# MIAMI BEACH

### Design Review Board

SUBJECT: DRB18-0223  
**216 Palm Avenue – Single Family Residence**

Palm Island PB6-54, July 15, 1920

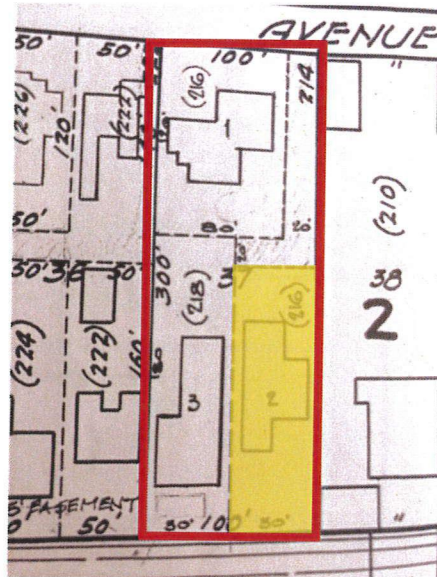
The subject property is a portion of a waterfront parcel, formerly known cohesively as Lot 37 on Block 2, on the southern side of Palm Island which was historically platted on July 15, 1920 with standard lots measuring 100 feet in width and 300 feet of depth.

Today the lot is 50 feet wide and 180 feet deep and contains approximately 9,700SF of lot area. The RS-1 zoning district requires lots to have a minimum lot width of 100'-0" and a minimum lot area of 30,000 SF in order to be a developable parcel.
